SERVICE BULLETIN NO. 398

TITLE NOISE FILTER INSTAL. - INTERIM FOR
SYSTEM IV SHIPSPURPOSE REDUCE INVERTER NOISE AND AUTOPILOT
NOISE AFFECTING SYSTEM IV

APPLICATION 370, 374, 376, 344

REF: R-32

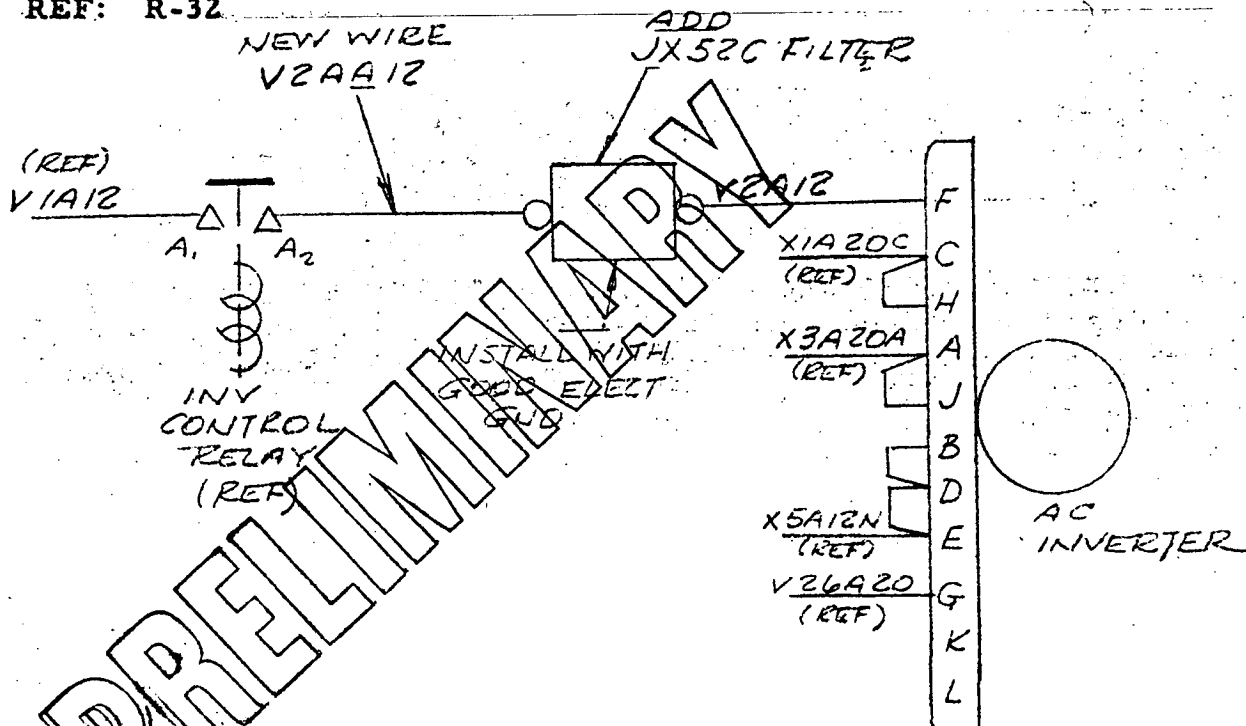
IN ORDER TO REDUCE INVERTER NOISE, INTRODUCED INTO THE 28V DC BUS SYSTEM AND WIRE BUNDLES OF THE EQUIPMENT BAY AREA, THE JX52C FILTER IS TO BE ADDED ON THE INVERTER SHELF. THE FILTER IS TO BE LOCATED WITHIN 6" OF THE INVERTER AND THE MOUNT IS TO BE A GOOD ELECTRICAL GROUND TO SHIP STRUCTURE.

THE JX52C FILTER IS TO BE ADDED IN THE Y2A12 WIRE FROM INVERTER TO INVERTER CONTROL RELAY. IT IS TO BE LOCATED WITHIN 6" OF INVERTER. THE V2AA12 WIRE IS ENCLOSED WITH SERVICE BULLETIN TO PROVIDE NEEDED WIRE LENGTH.

REF: R-55

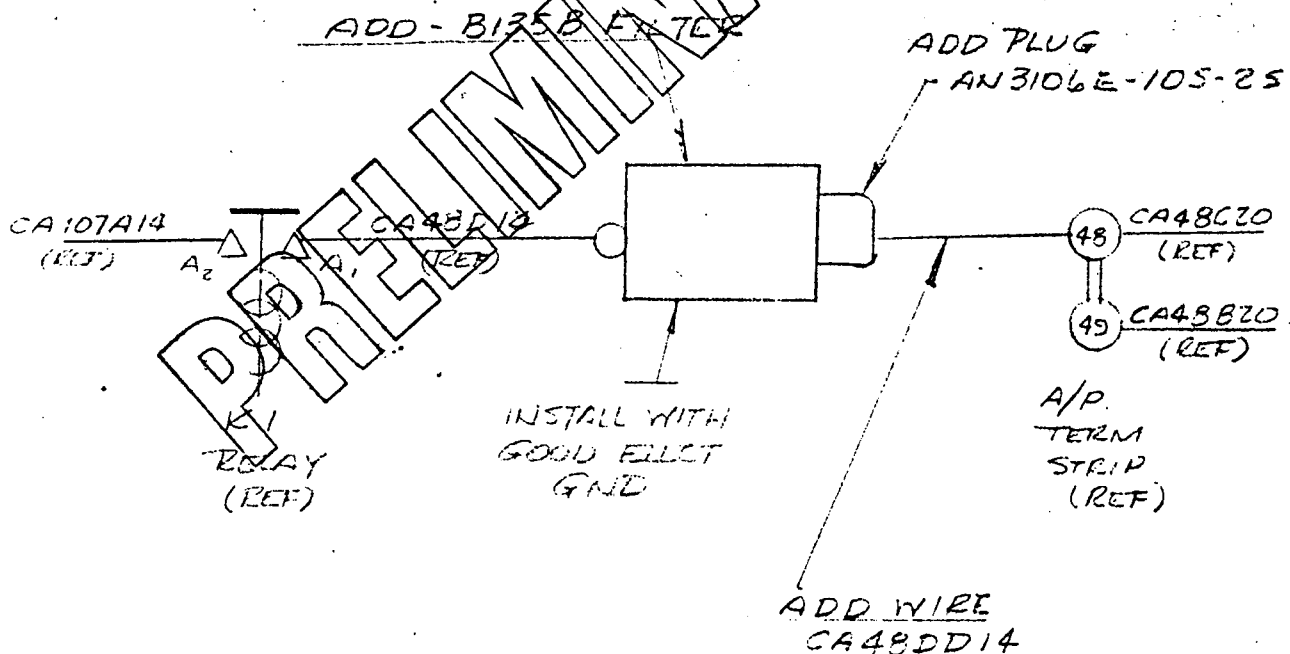
IN ORDER TO REDUCE TRANSIENT SPIKES OF 15 TO 20 VOLTS AMPLITUDE INDUCED IN R. H. WIRE BUNDLE AND NOISE TERMINAL STRIP AREA THE FOLLOWING FILTERS ARE TO BE ADDED.

- A. INSTALL B-135-B FILTER IN DC POWER CIRCUIT TO GYRO CONTROL AMPLIFIER. FILTER TO BE LOCATED ON NOSE RACK JUST BELOW PANEL SUPPORTING YAW DIRECTIONAL GYRO.

- B. INSTALL B-135-B FILTERS IN ELEVATOR TRIM MOTOR CIRCUIT. (ONE IN ELEVATOR TRIM UP CIRCUIT, ONE IN ELEVATOR TRIM DOWN CIRCUIT) FILTERS TO BE LOCATED ON HAT SECTION IN VICINITY OF K5 AND K6 RELAYS AND HUNG FROM HAT.
